CITY OF ALBUQUERQUE

RE: **THE TRAILS UNIT 4 (East of Unser Blvd. NW)** (C10 – D 001)
DRAINAGE MASTER PLAN (PE Stamped 04-24-08)

DRAINAGE MANAGEMENT PLAN

THE TRAILS UNIT 4

SHEET 1 OF 2

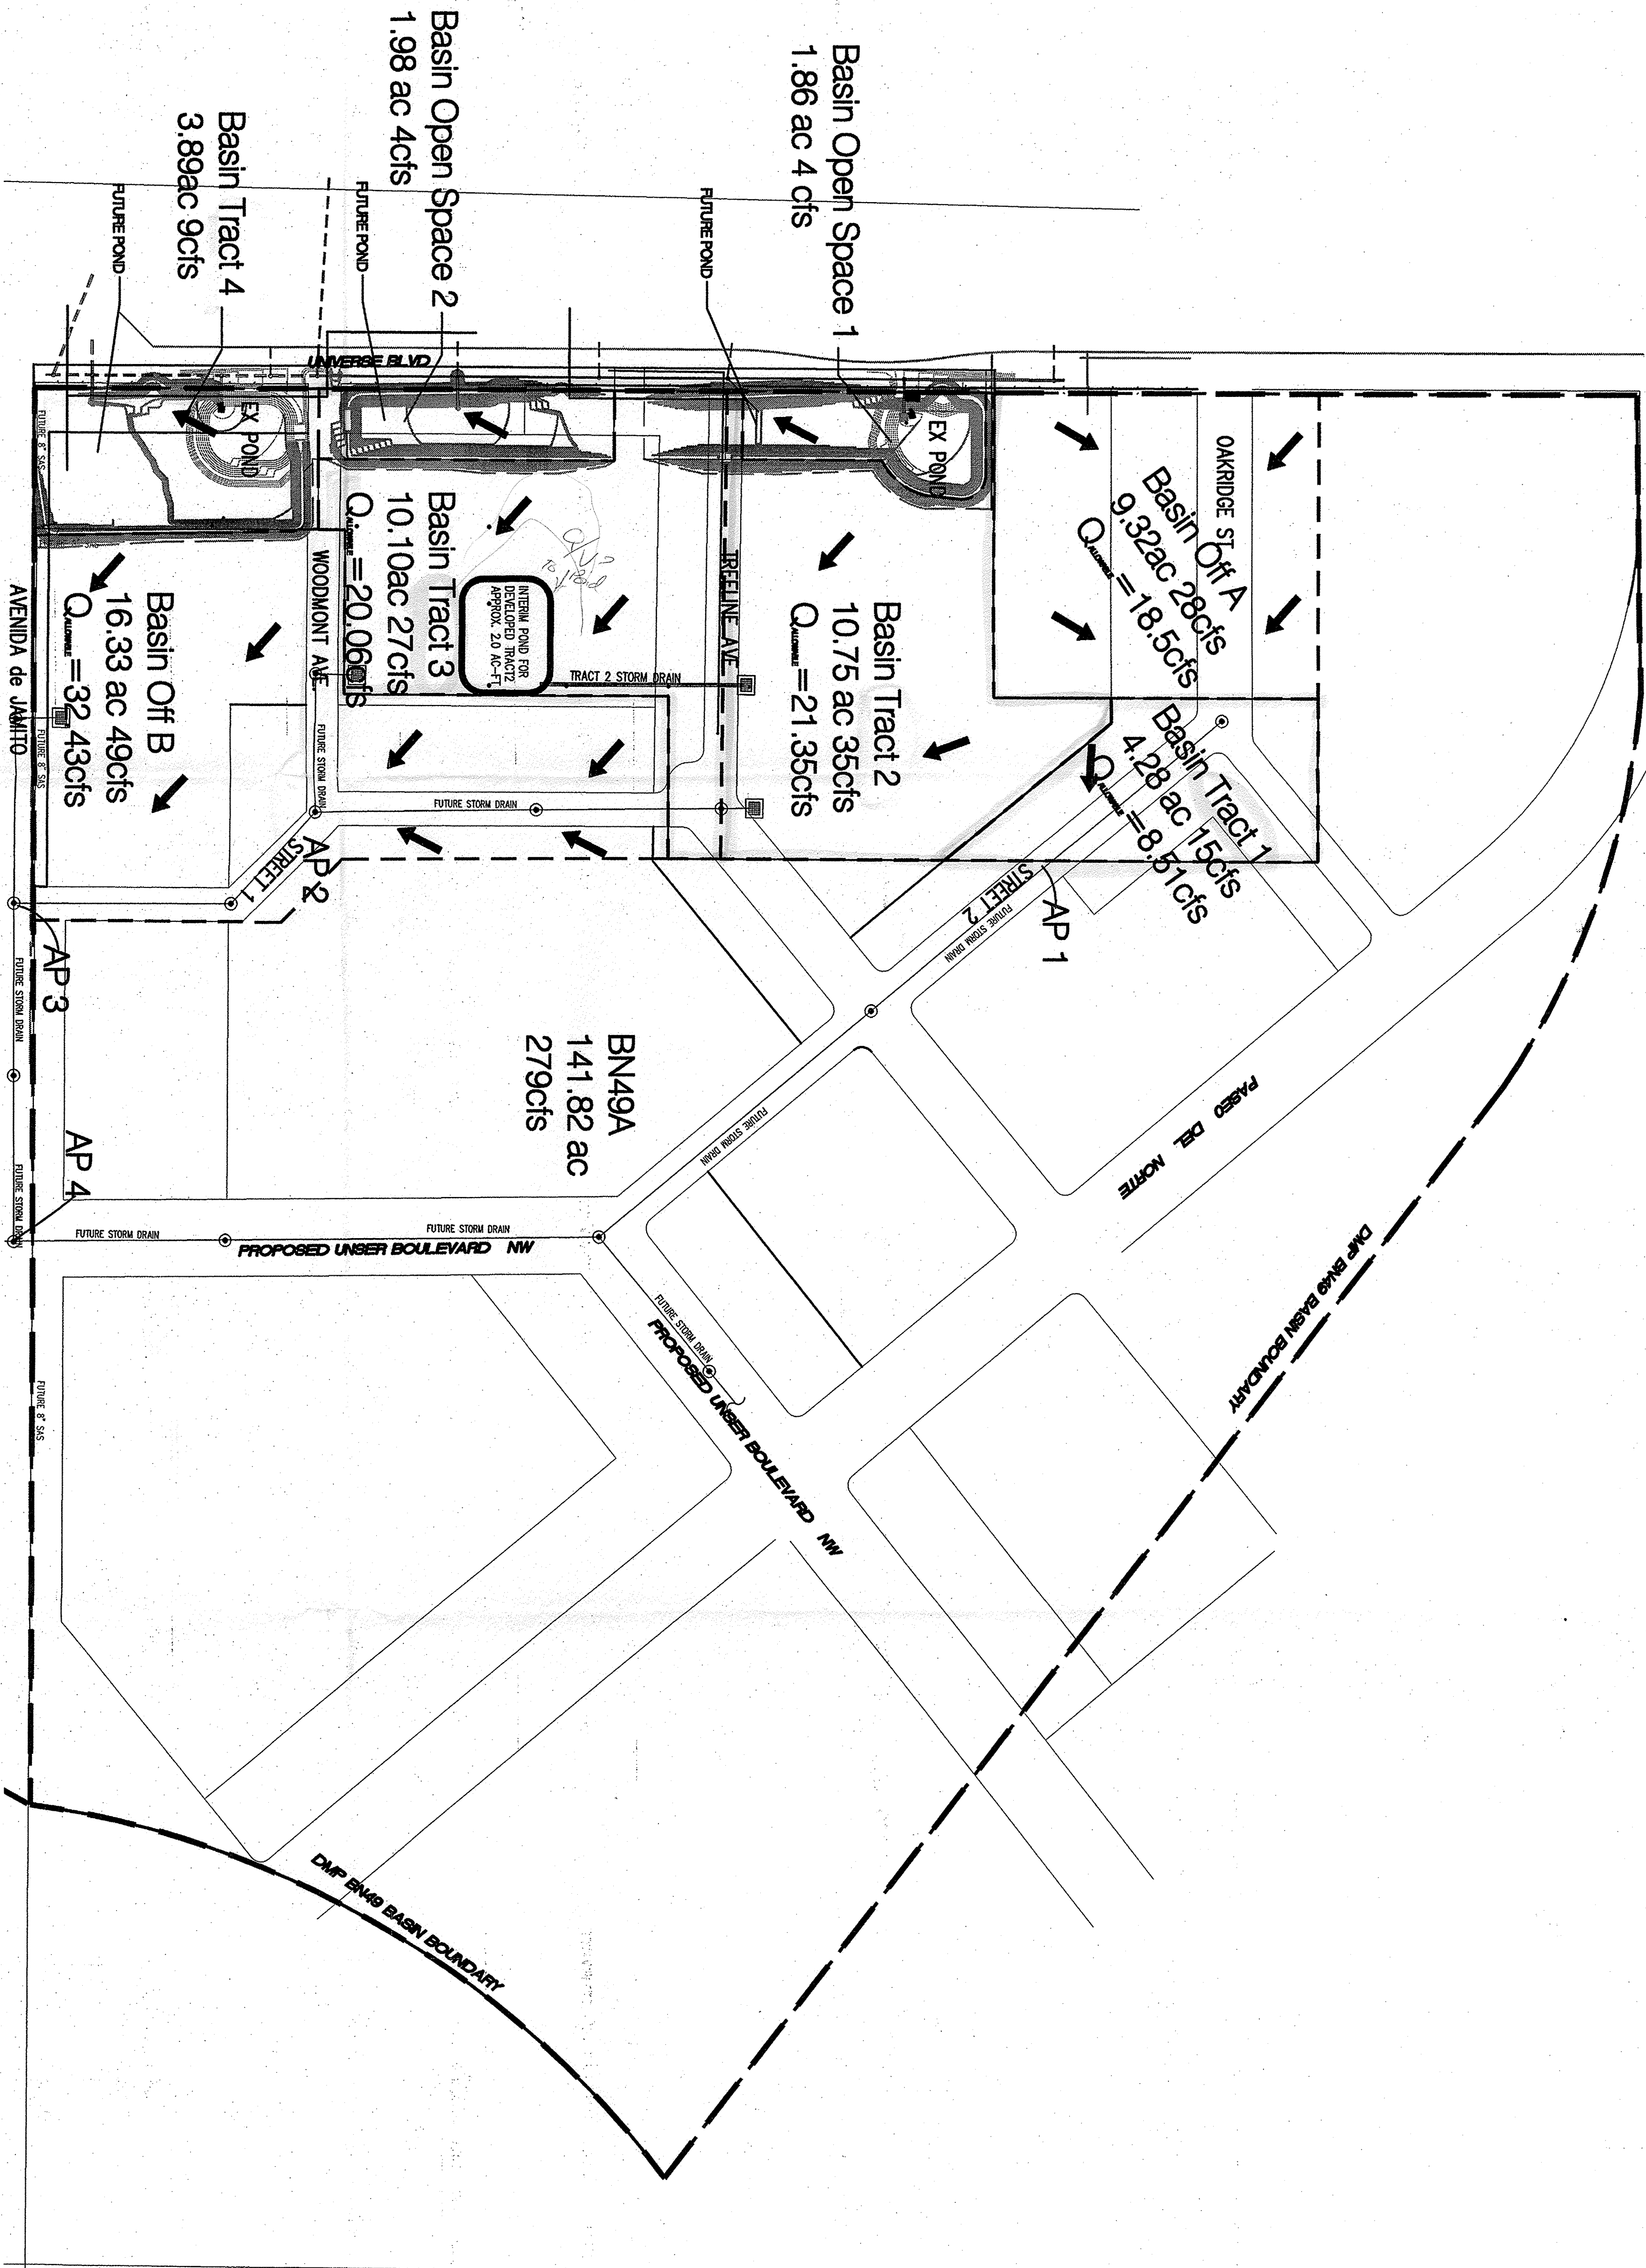
A site specific Grading and Drainage Plan in compliance with this DMP must be submitted for each phase of Unit 4, including a detailed Grading and Drainage Plan for Tract 2. The proposed "Interim Retention Pond" for Tract 2, located on Tract 3, must be sized to include interim flows entering the pond from Tract 3.
